## CR165 – Tightening torque of eccentric hub fastening screw update

Panigale V4 (all Model years and versions) Technical Service Bulletin SRV-TSB-18-018

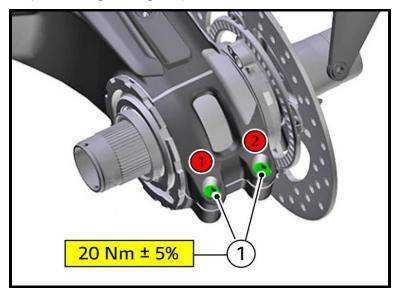
Ongoing product quality tests have detected a potential noise coming from the rear eccentric hub. This noise presents as a "clicking" sound that can be heard by handling the motorcycle by hand and with engine off.

The solution is to reduce the tightening torque of the two M10x35 screws fastening the eccentric hub to the swingarm on all the concerned motorcycles. It is necessary to update the tightening torque of the **2 M10x35 screws (1)** to the value of  $20 \text{ Nm} \pm 5\%$  by following the sequence 1-2-1 for all affected units. (the previous tightening torque was 25 Nm ± 5%)

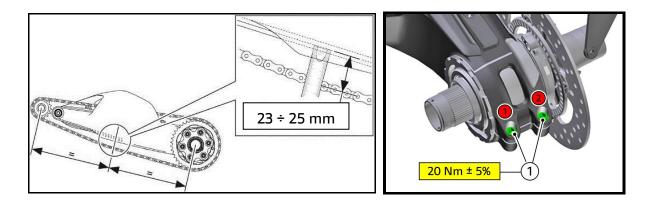
- 1. Set the motorcycle on the side stand
- 2. Loosen the 2 M10x35 screws (1) fastening the eccentric hub to the swingarm
- **3.** Tighten the **2 M10x35 screws (1)** to the new tightening torque of <u>**20 Nm ± 5%** following</u> <u>the sequence 1-2-1</u>
